**TOWN OF BAY HARBOR ISLANDS
PLANNING AND ZONING BOARD**

TOWN OF BAY HARBOR ISLANDS COMMUNITY DEVELOPMENT MEMORANDUM

Subject: Site Development Plan Application – Revisions 2020
9350 Bay Harbor Terrace Townhouses (6 DU)
9350 Bay Harbor Terrace
Revisions to Exterior Building Façade / Interior Revisions
Ground Floor FEMA Revisions / Add 4th Floor / Revise Roof Level
Bay Harbor Islands Acct. No. MB2015-79
MMPA Acct. No. 01-0702-1003

MMPA recommends the Planning and Zoning Board (PZB) review the most recent revised plans prepared by George E. Peon Architect, A.I.A. last revised June 1st, 2020 and, if found acceptable, **APPROVE** the proposed Site Development Plan revisions subject to the recommended staff conditions listed hereinafter.

SITE PLAN
SCALE: 3/32"=1'-0"

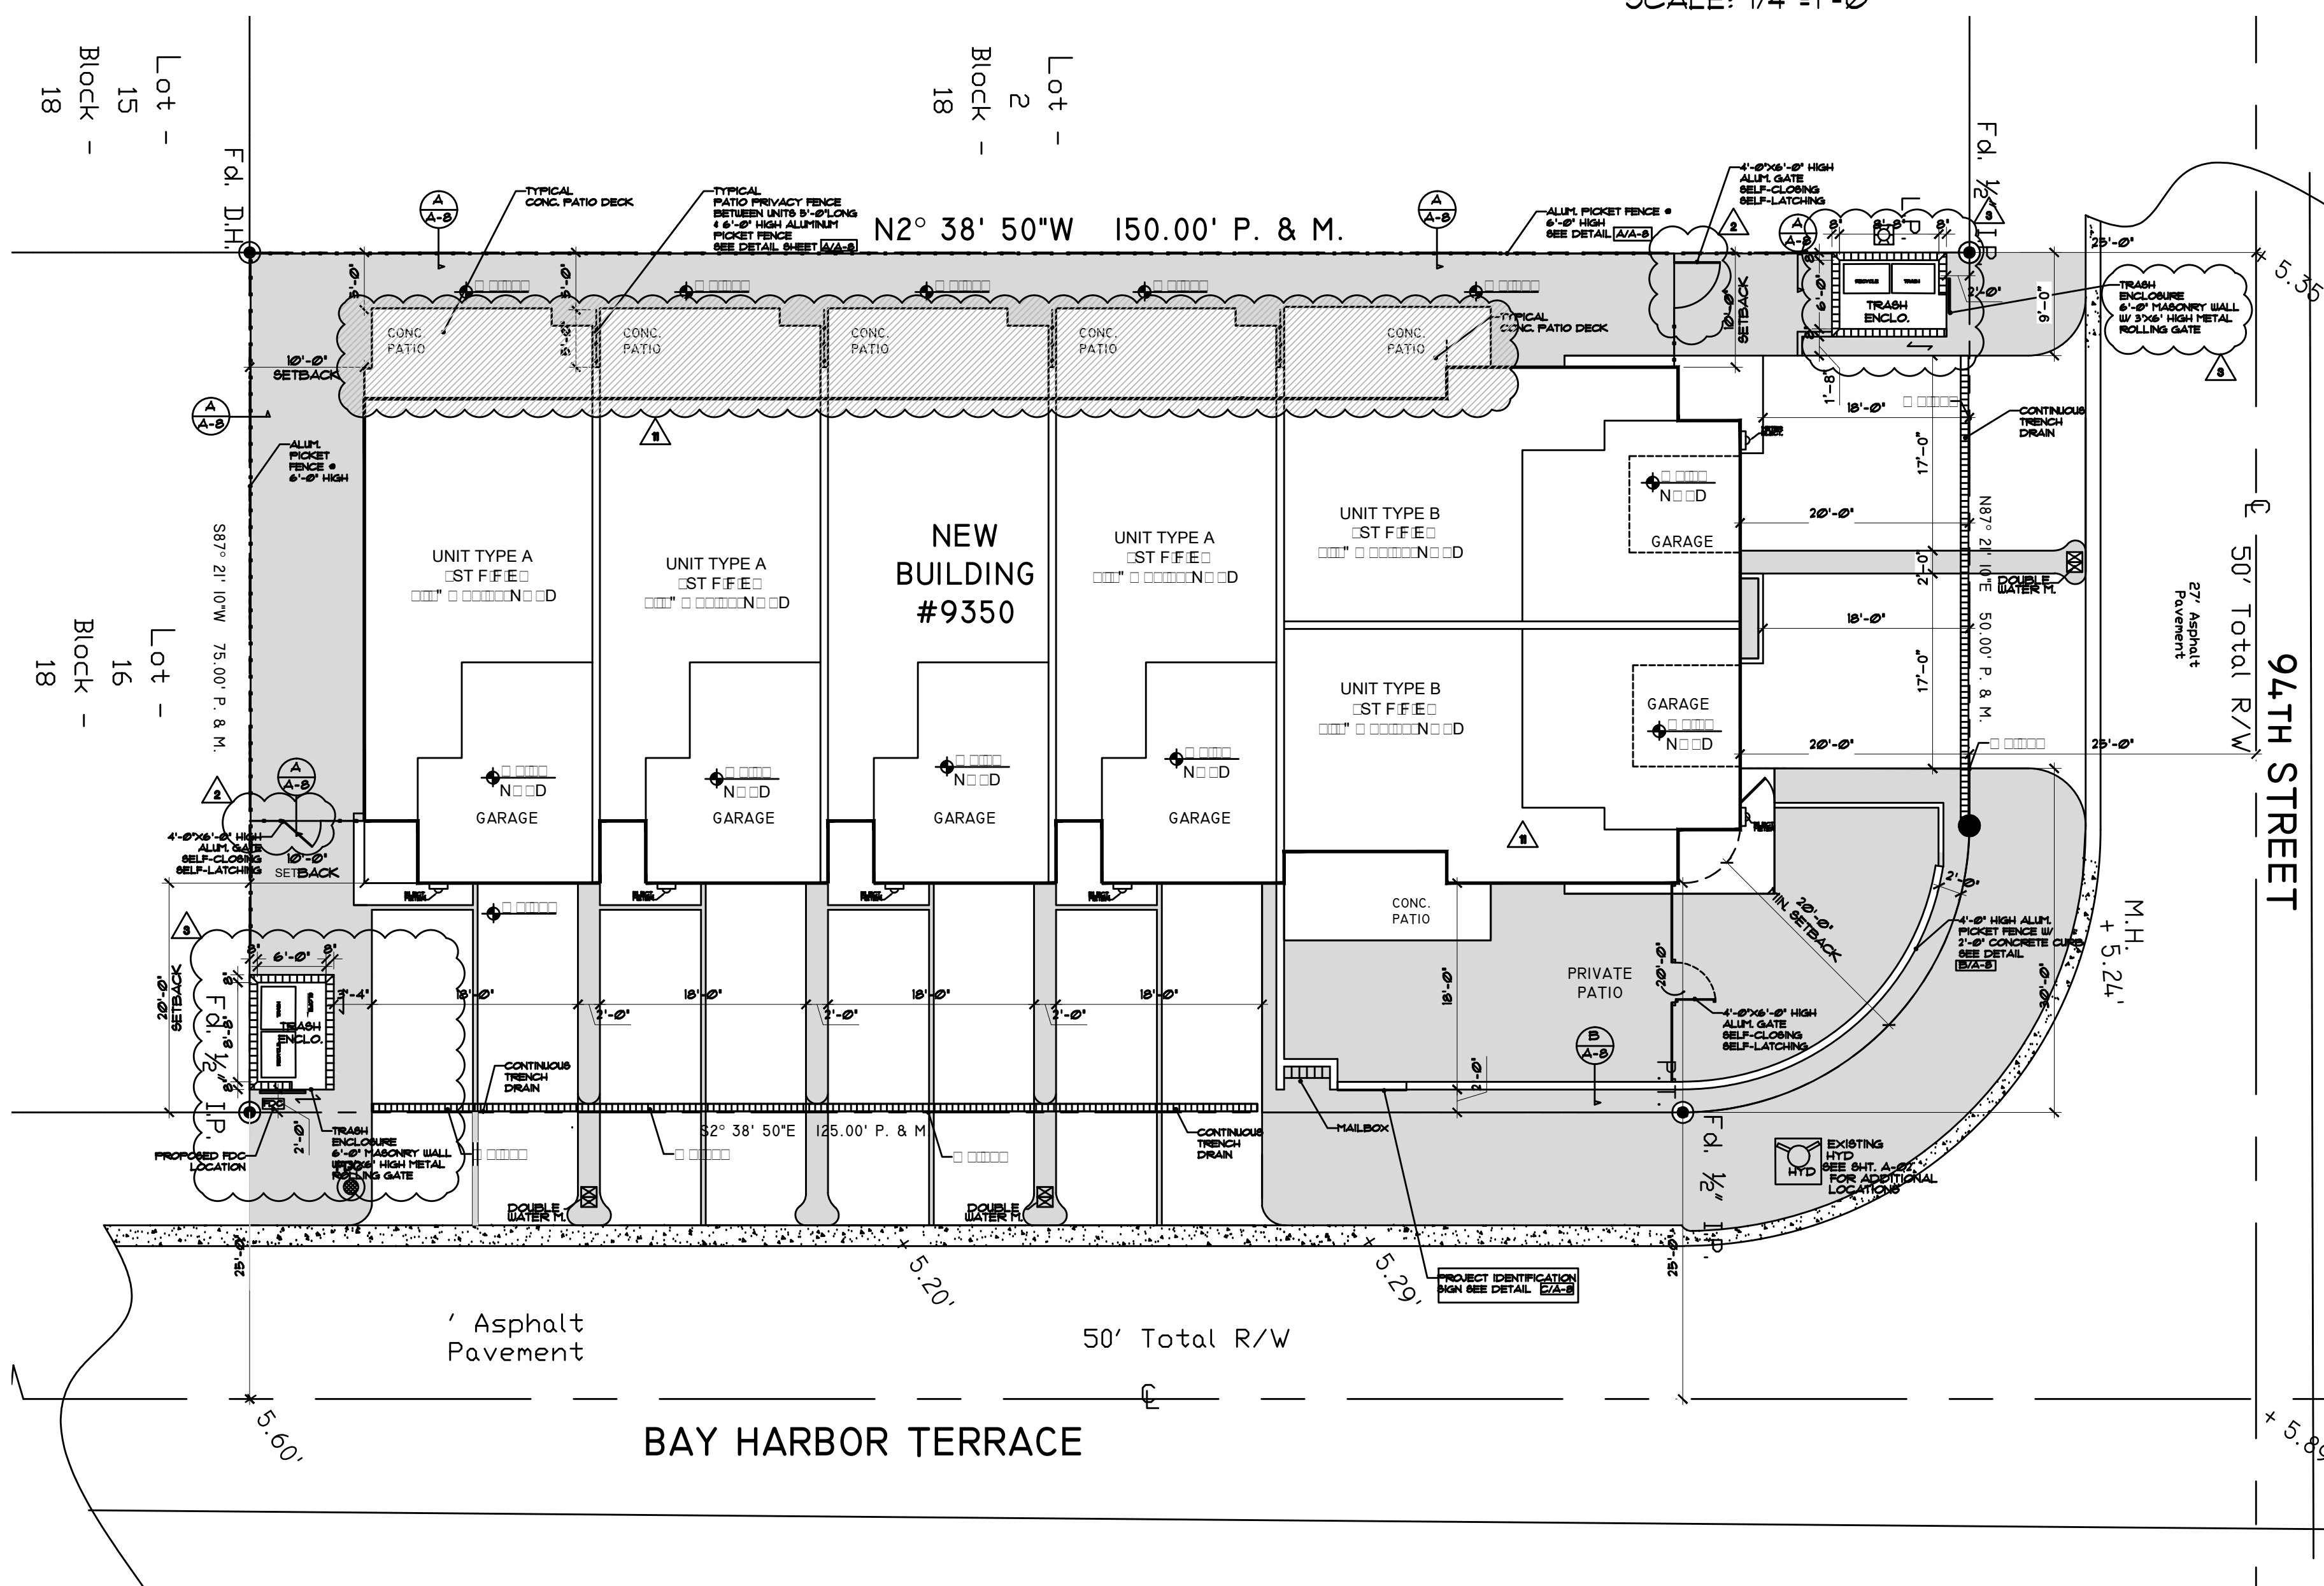
The patio area on the west side of the units has been revised to include a portable spa, outside shower, sink and storage closet. The size of the concrete patio decks is also being increased for the 5 units except for the northwest unit along 94th Street. The northeast corner unit also includes a portable spa, outside shower, sink and storage closet. Despite this adjustment at least 20% of the site is still pervious / landscaping (26%).

PROPOSED 4TH FLOOR PLAN
SCALE: 3/16" = 1'-0"

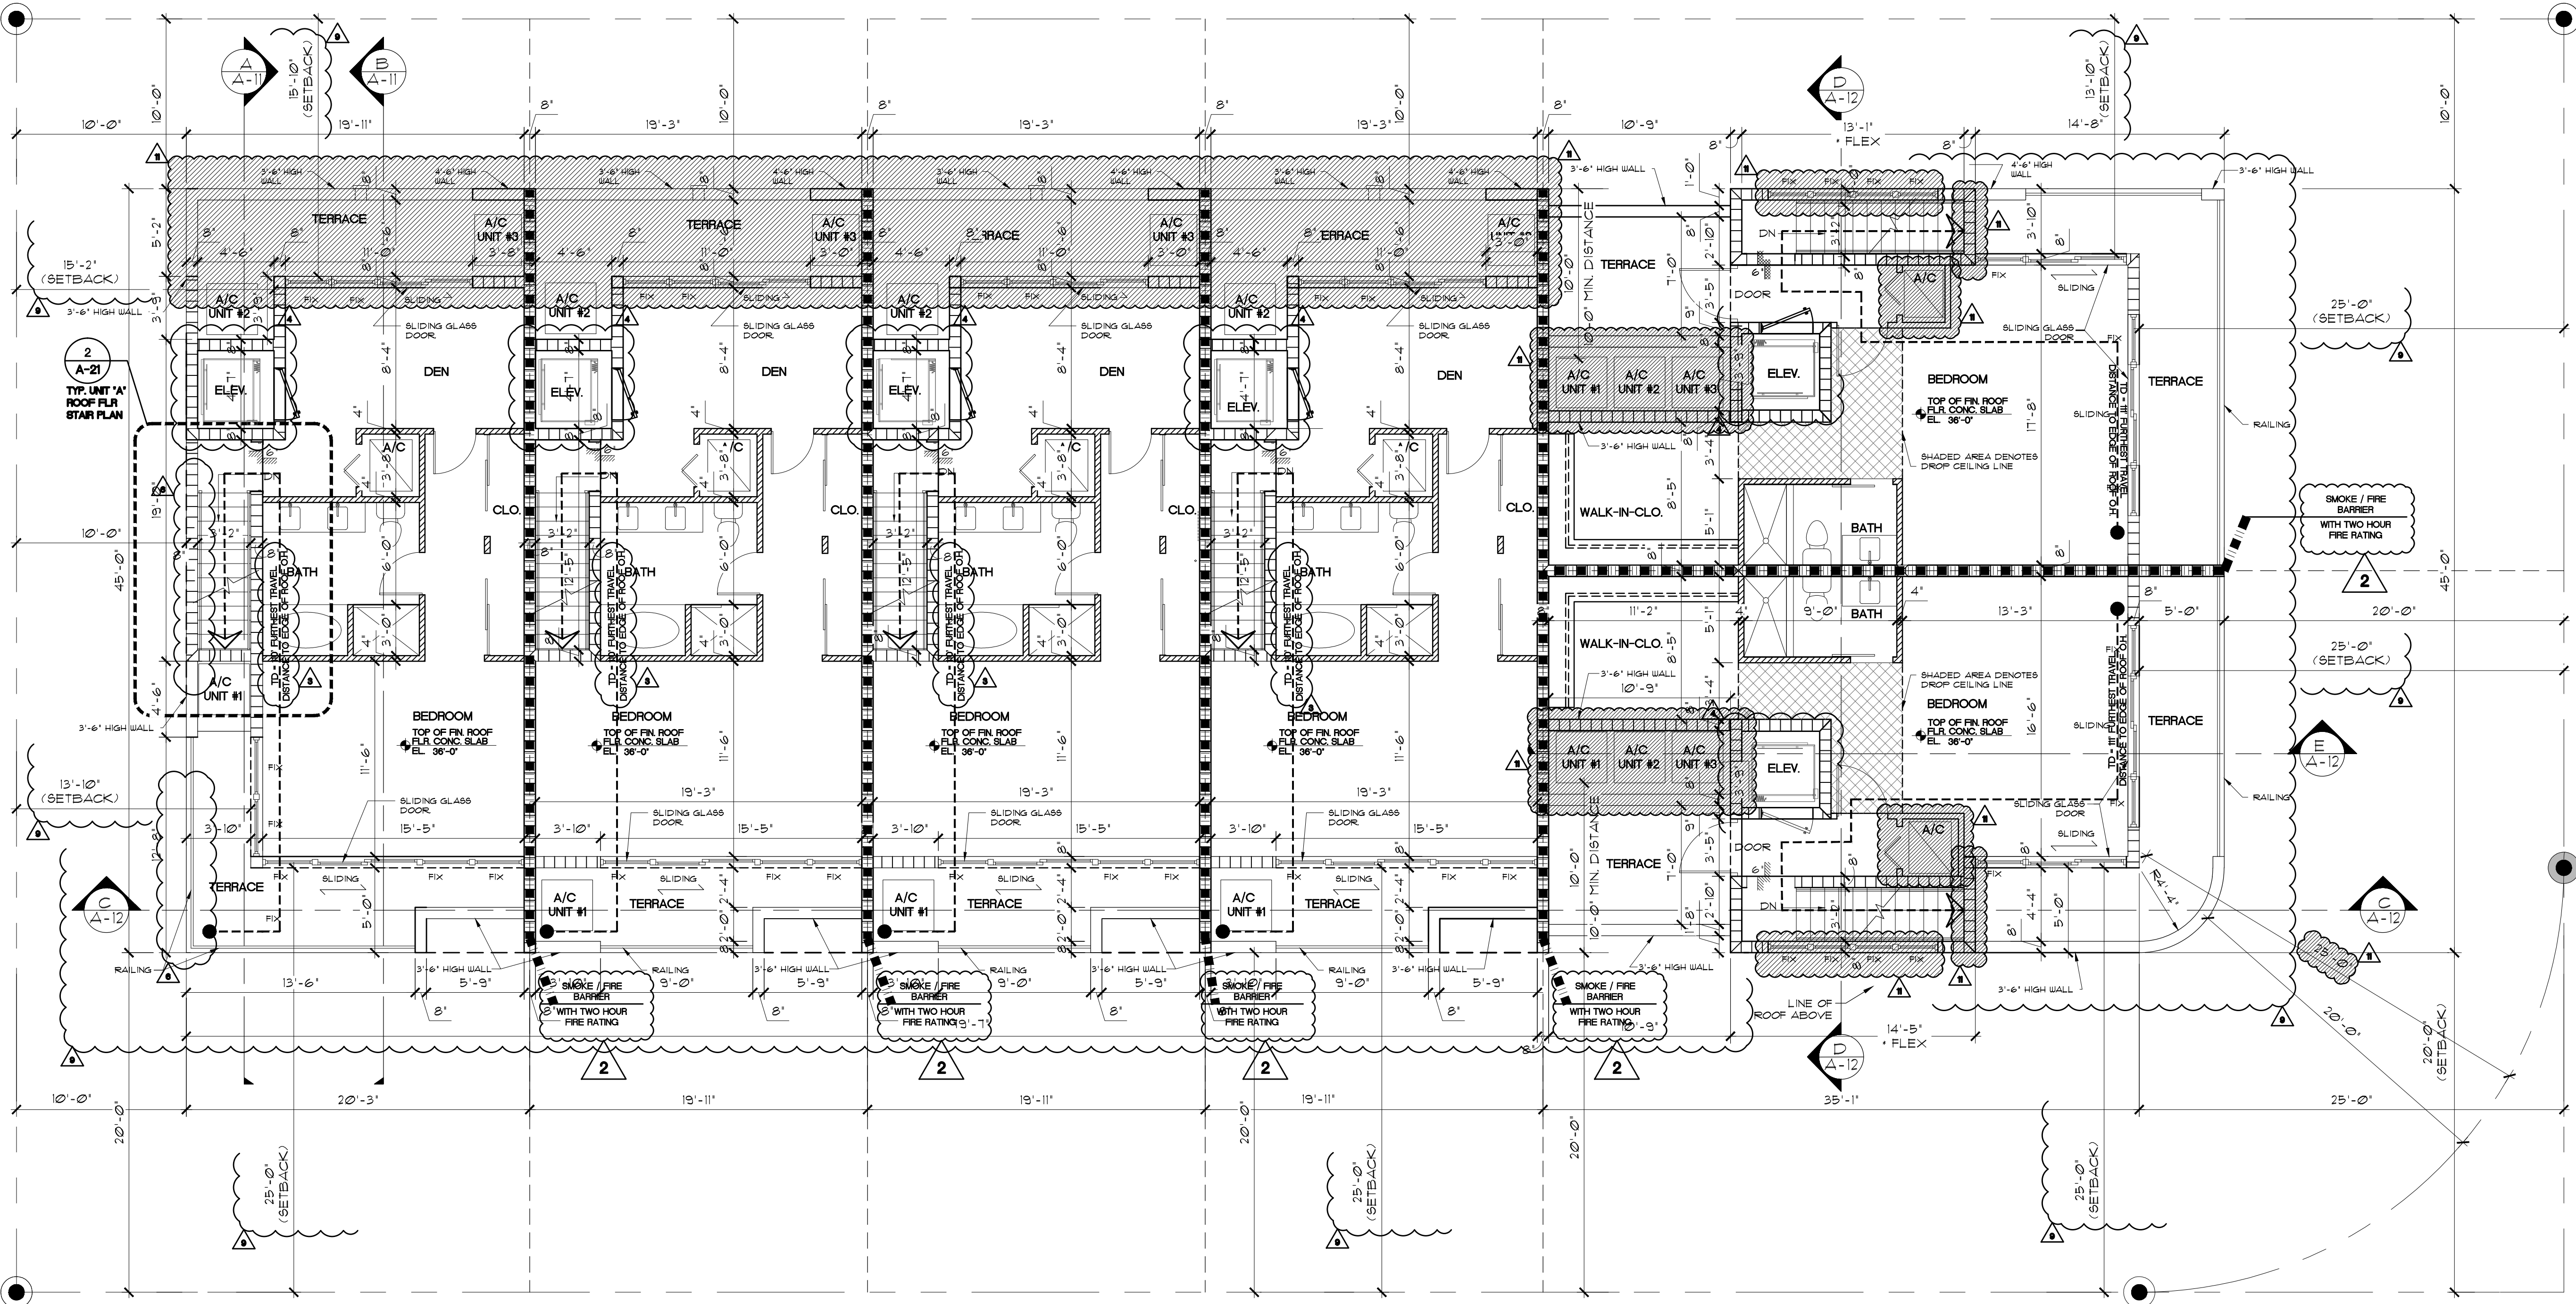
A new 4th Floor Plan was added for the entire building (all DU) adding new living area lost from the ground floor revisions. This includes a terrace along the east & west sides of 4 DU along with a den, bedroom, and bathroom for each DU. The 2 northern end units have a wraparound terrace along the north, east and west and the interior includes a living area, bedroom, walk in closet and bathroom.
